**OFFICE OF RATEPAYER ADVOCATES
CALIFORNIA PUBLIC UTILITIES COMMISSION**

**REPORT ON PLANT – REGION 1
Golden State Water Company
Test Year 2016 General Rate Case
A.14-07-006**

**San Francisco, California
March 6, 2015**

Figure 1-A 2009-2012 MDD Trend in the Arden System.⁴⁰

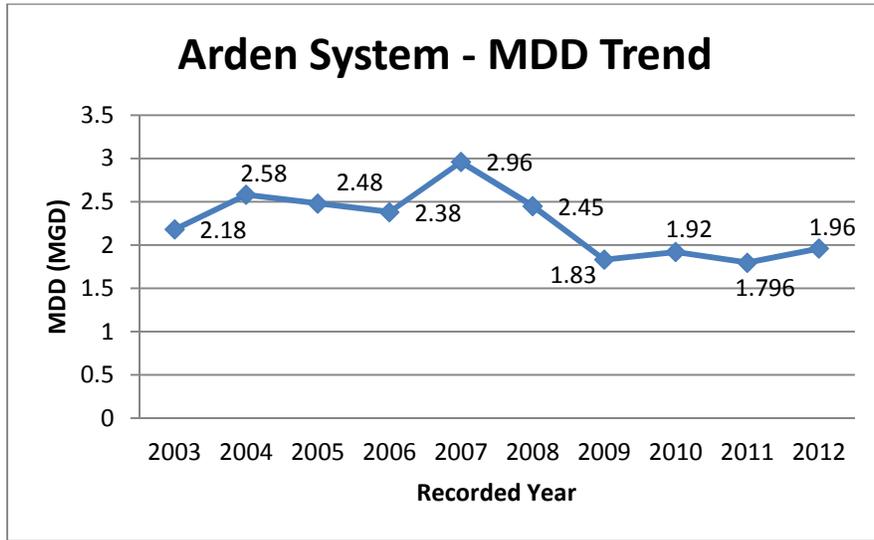
14 Without a satisfactory explanation for the unusually high 2010 MDD value reported to ORA,
15 ORA uses the demand data found in the 2013 Arden CDPH/DDW Report in its supply and
16 demand analysis for the Arden system.

10 **Figure 2-A Recorded MDDs vs. 2009 Los Osos Water Master Plan MDD Projections**

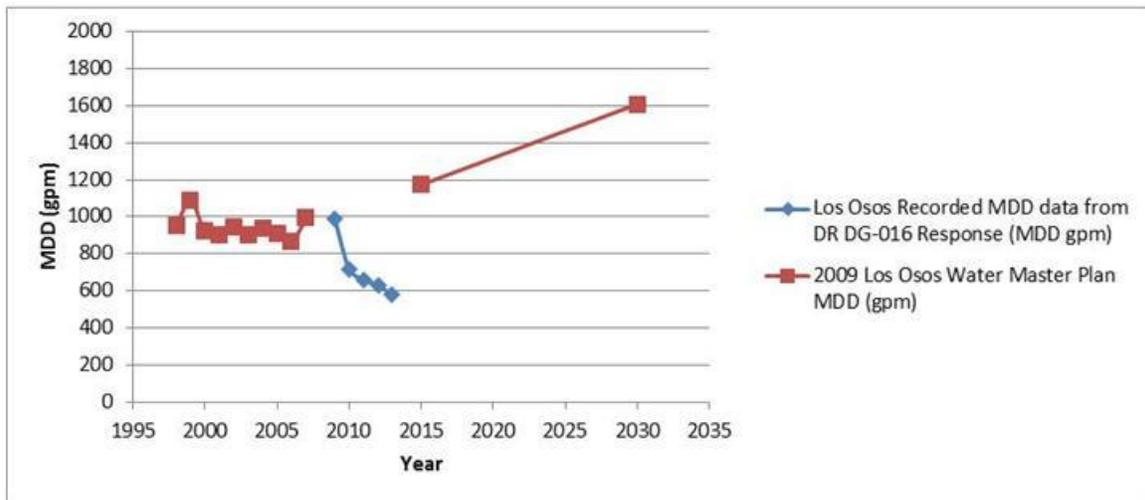
8 The declining trend is clearly reflected in **Figure 2-A** below, which shows recorded MDD data
9 as compared to the 2009 Plan’s MDD projections.

11
12 GSWC relied on the 2009 Los Osos Water Master Plan data in formulating the request for a new
13 well in Los Osos, without reconsideration of demand assumptions. As shown in **Figure 2-A**
14 above, the recorded demand in terms of MDDs have been significantly lower than in the 2009
15 Plan. Every year from 2009 to 2013, the MDD decreased steadily, from 989 gpm in 2009 to 577
16 gpm in 2013.²⁰² In comparison, GSWC’s 2009 Plan assumed a 2015 MDD of 1,174 gpm,²⁰³

8 **Figure 2-B Los Osos System’s Well Capacities and 2013 MDD.**

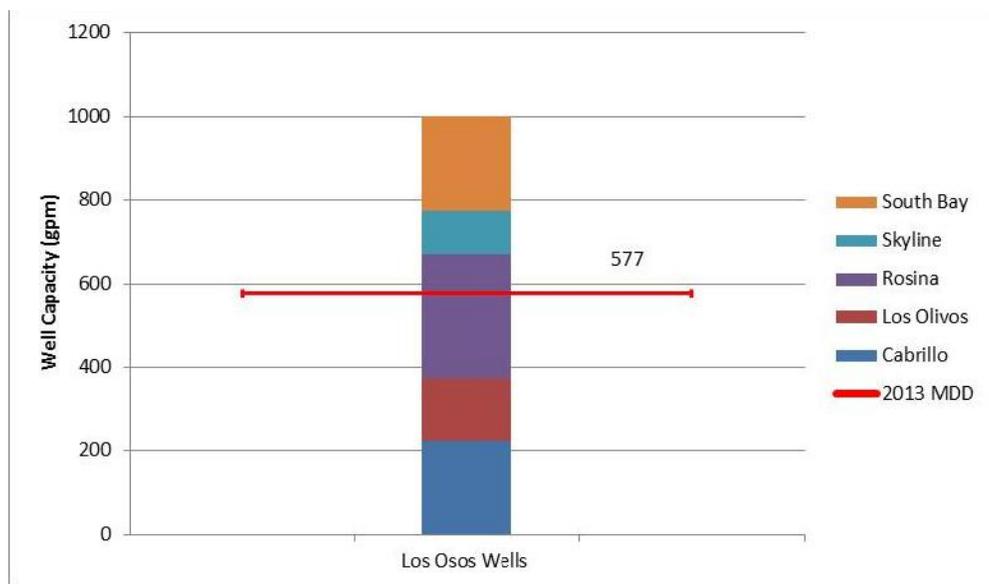
4 A more accurate representation of the supply and demand situation in Los Osos is shown in
5 **Figure 2-B** below. As shown, Los Osos’s total well supply far exceeds its MDD in 2013. It is
6 reasonable to expect that supply excess will continue or even expand as GSWC continues
7 conservation efforts as directed by the Commission and funded by its ratepayers.
